## SCS ENGINEERS

Subject: Response to RAI No. 2  
Citrus County Central Class I Landfill  
7-Acre Re-Closure Construction Certification  
Permit No. 21375-014-SF/01, Citrus County  
WACS No.: SWD/09/39859

REVISED RECORD DRAWINGS SHEET 10 OF 27

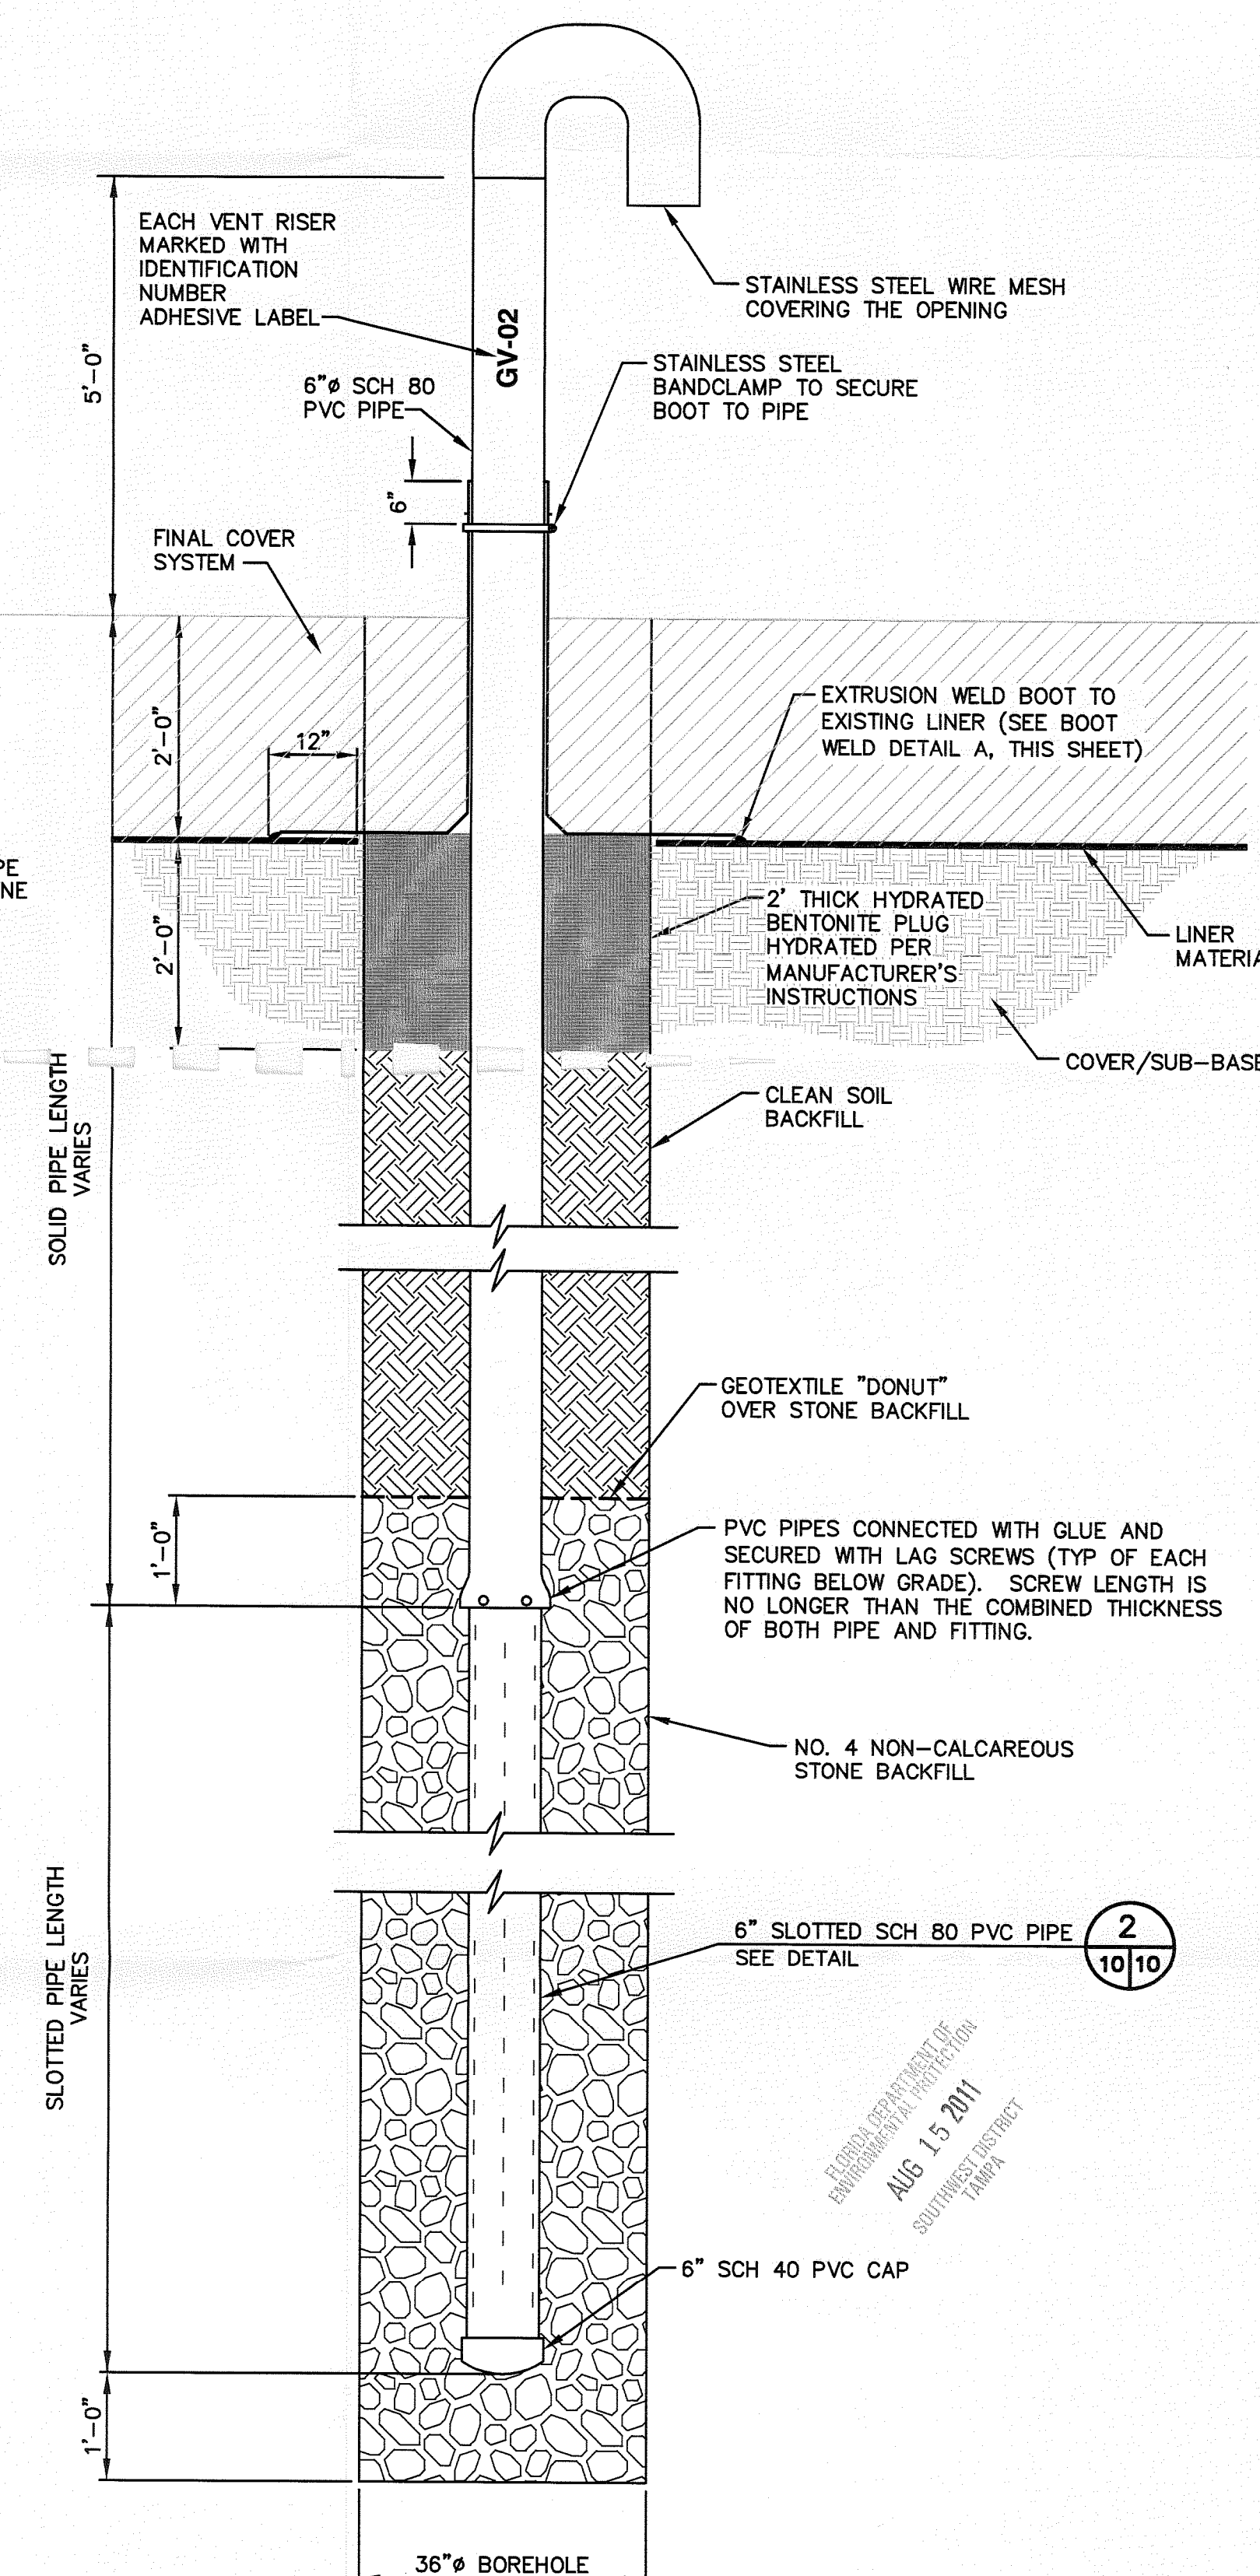
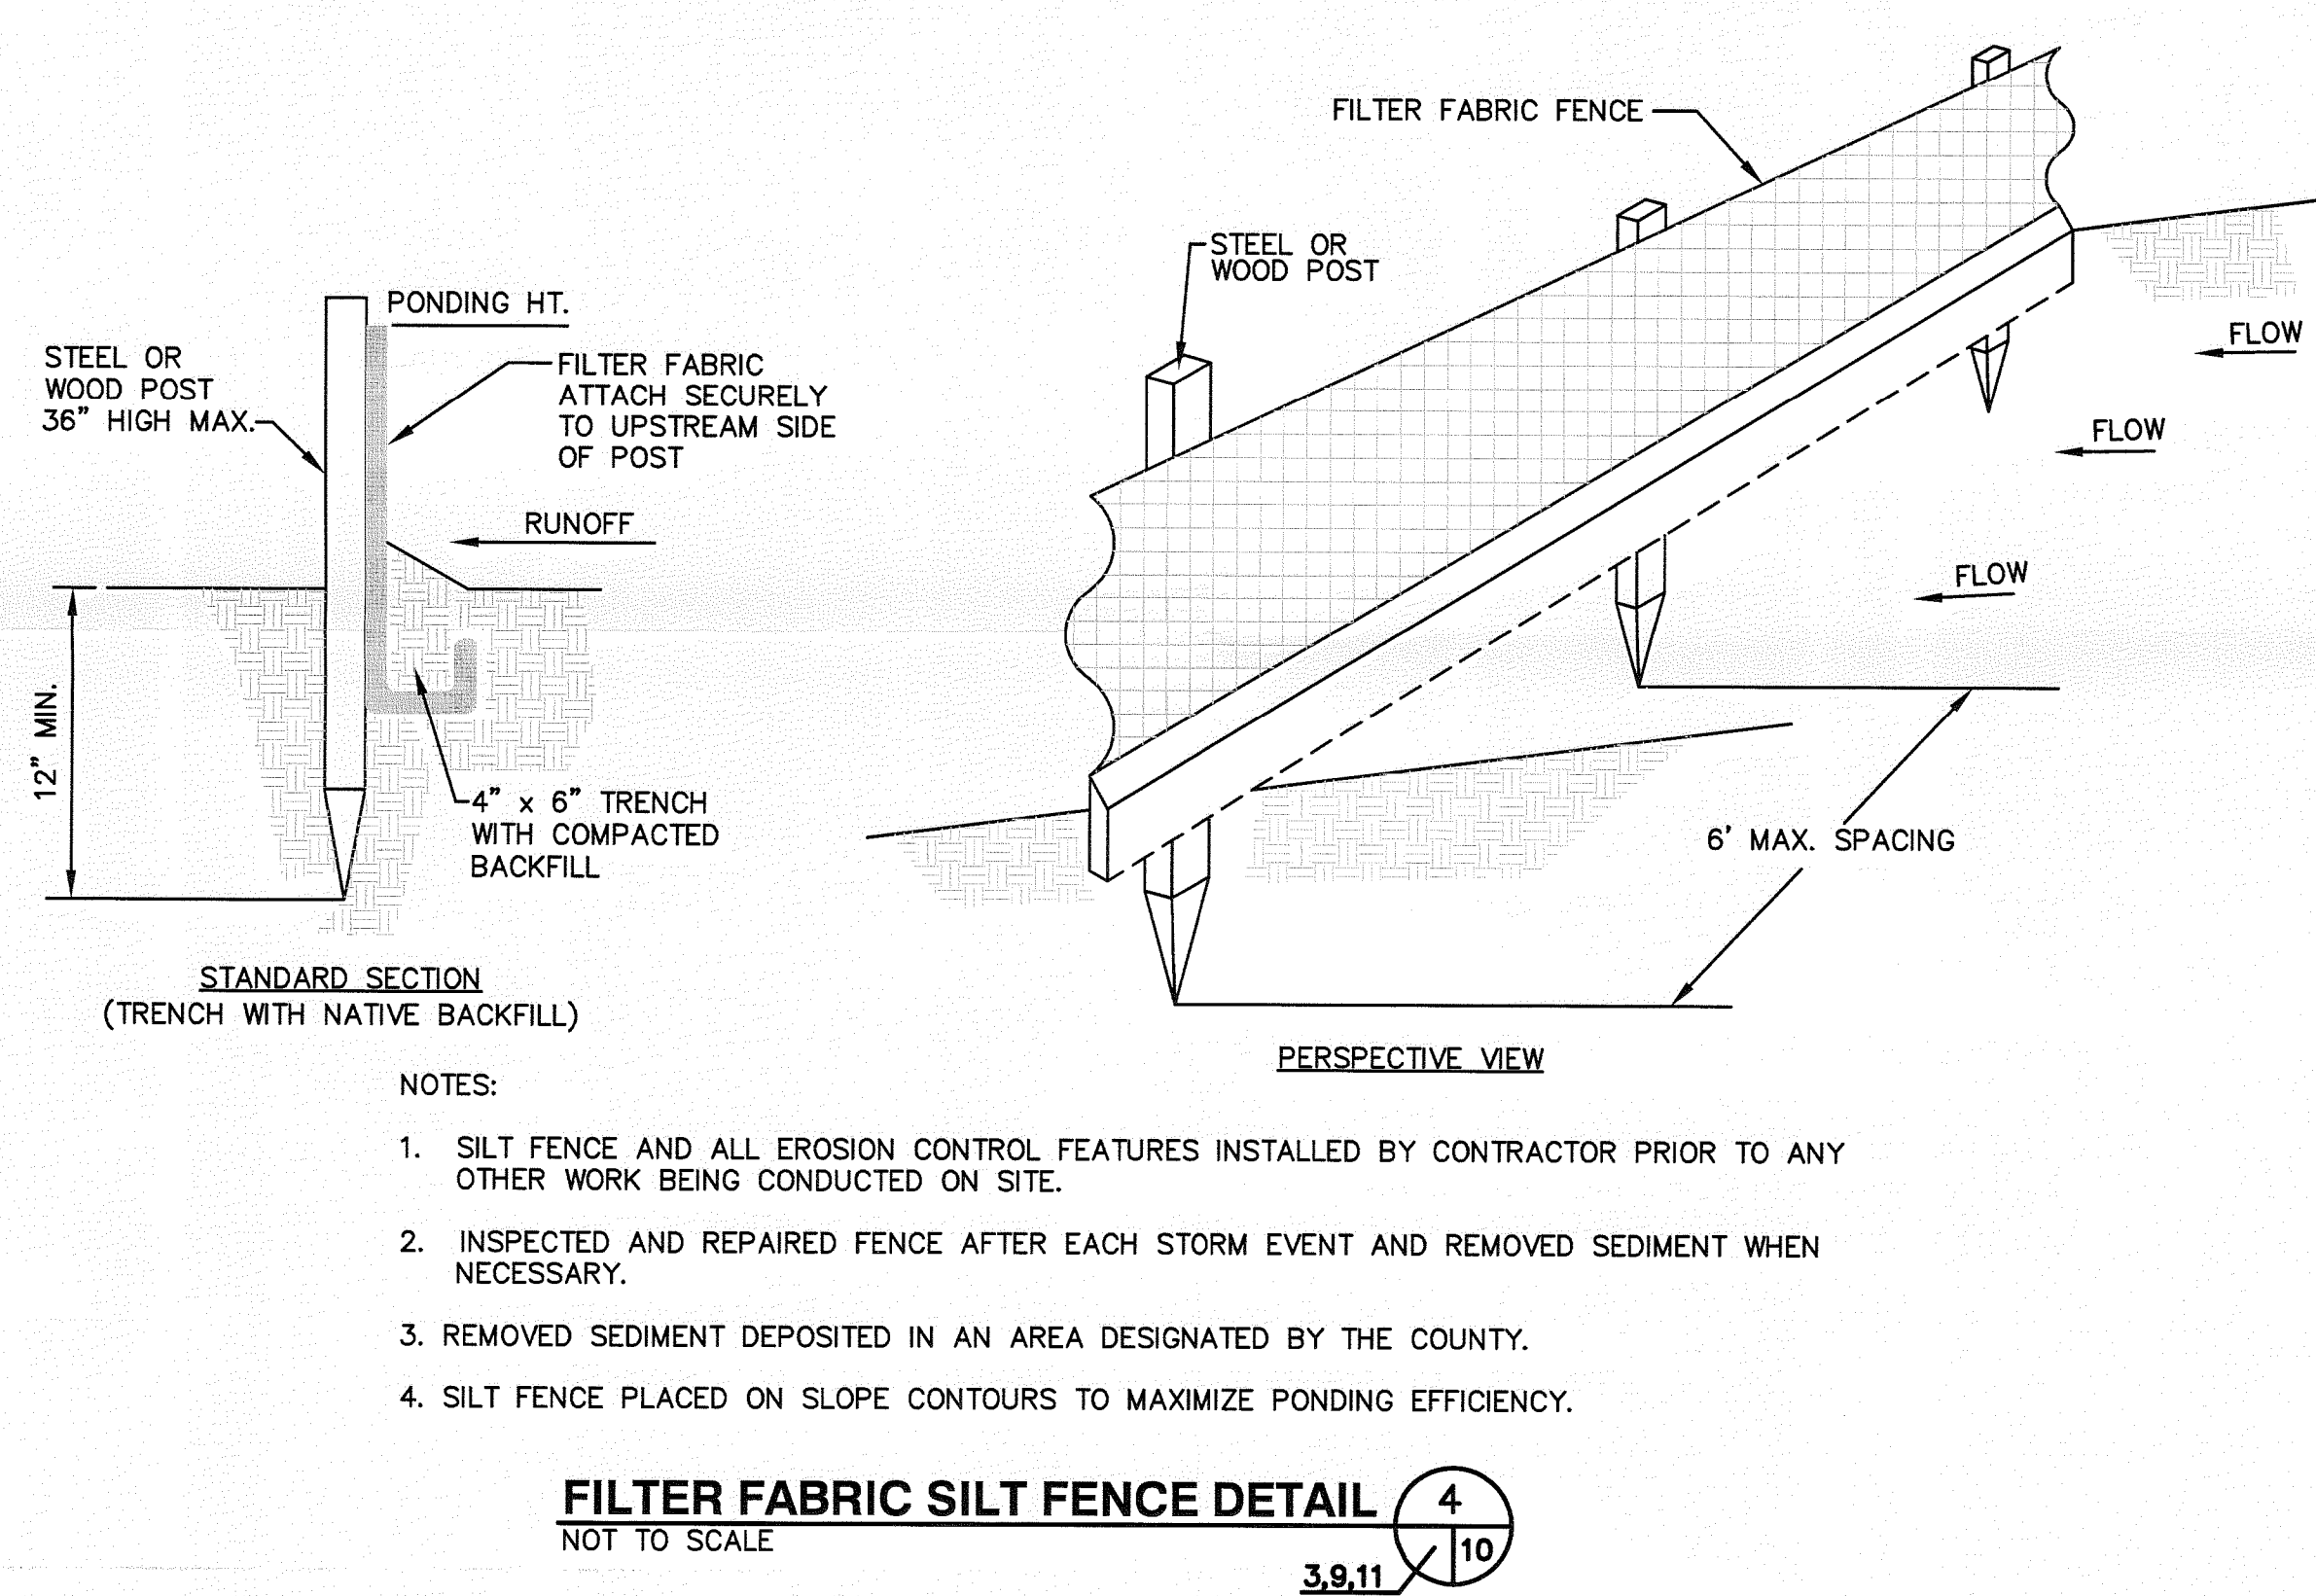
a. **Vent Schedule:** The reported slotted pipe length of 11 ft. for gas vent GV-6 appears inconsistent with the boring log on the vent construction log for GV-6 in Appendix C, which appears to indicate that the slotted pipe is installed approximately from 19 ft to 34 ft below ground surface. Please verify and revise this sheet and/or the vent construction log, as appropriate.

**Response:** Attachment 1 contains a new Sheet 10 in which the correct well depths, solid and slotted pipe lengths are given and noted. Attachment 3 contains a revised boring log for GV-6 in which the 11 feet of slotted pipe has been increased to 15 to indicate the appropriate amount of installed pipe.
